## Groundwater & Wastewater Services
### Well Project File & Data Review Worksheet

# PERMIT TO CONDUCT MAJOR REPAIR AND/OR ABANDON A WATER SUPPLY WELL

**Rept. for ARGU Review**
**8501 Trexler Ave., Charlotte, NC**
**PID# 113-106-04**
**File # 6973B**
**Application#1957**

**Charlotte Douglas Int'l Airport New Runway Project - 2007 Water Well Abandonment Record 4 of ___** B-21

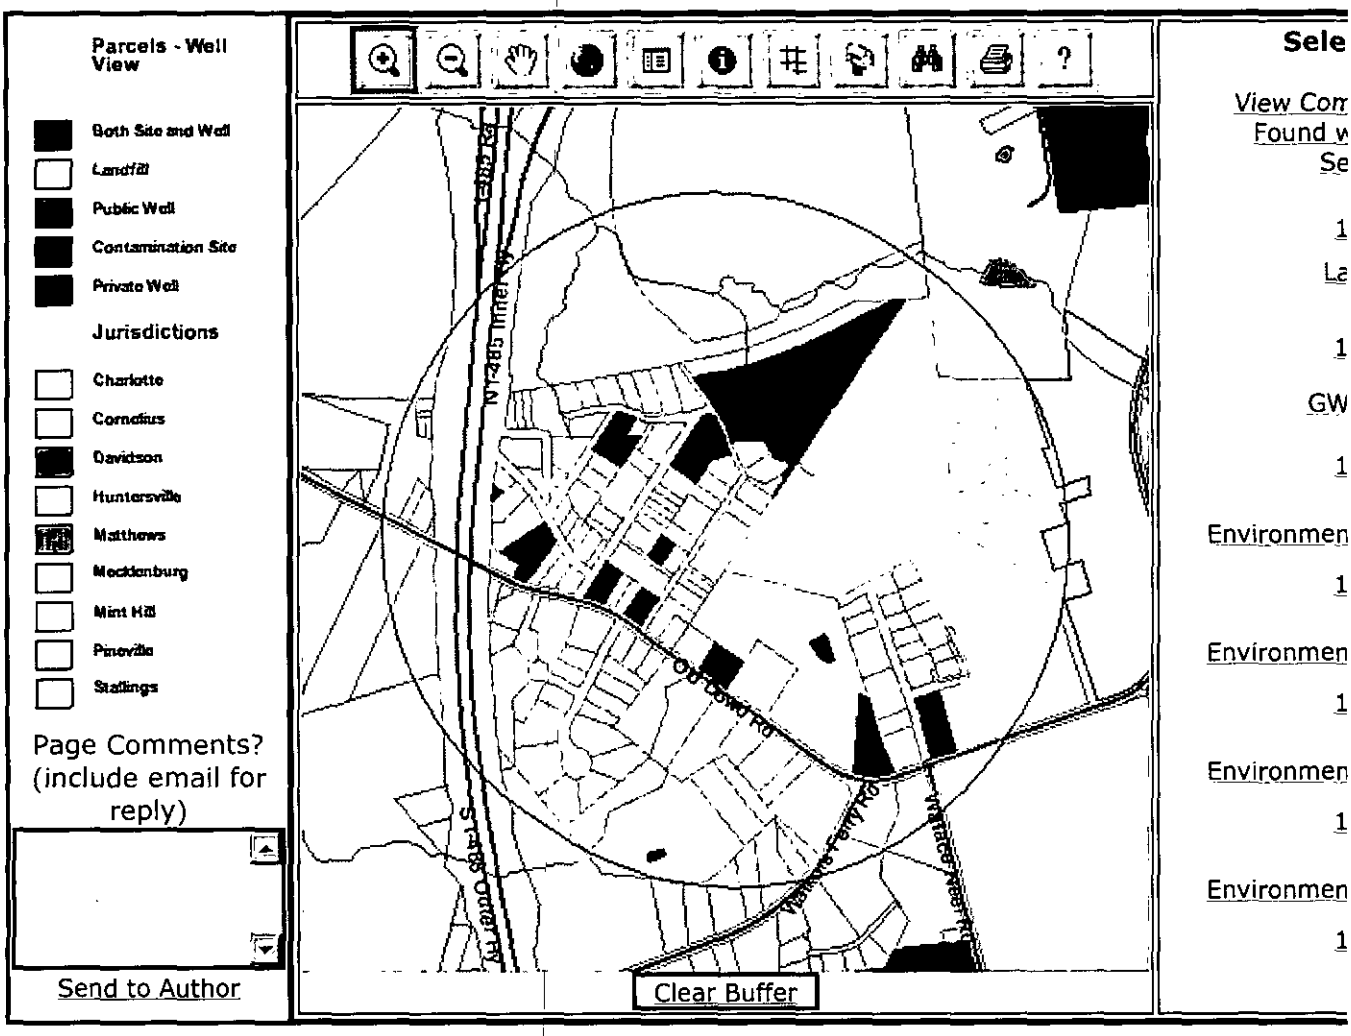
02/26/07 (Mon.) - Conducted ARGU Review. Identified 1 MPL site within 2,000' of the subject parcel.

MPL# 1069 Charlotte/Douglas International Airport
7200 Old Dowd Rd., Charlotte, NC
PID# 113-093-33
LCIDP LF

File review for Charlotte/Douglas International Airport indicates this is an open private permitted land clearing and inert debris landfill.

NOTE: Mandatory setback for a new well is 100-ft from a LCIDP LF.

The closest parcel boundary for the subject site is more than 1,500' from the parcel boundary for the landfill.

Based on review of our files, the permit for a private well abandonment at PID# 113-106-04, 8501 Trexler Ave., Charlotte, NC is approved. The referenced MPL site is outside of the ARGU and more than 100' from the well location, the setback required for a LCIDP LF, so the well requires abandonment under the Mecklenburg Co. Groundwater Regulations dated Oct. 5, 2004, Chapter II Construction, Repair and Abandonment for Private Water Supply Wells with no special conditions.
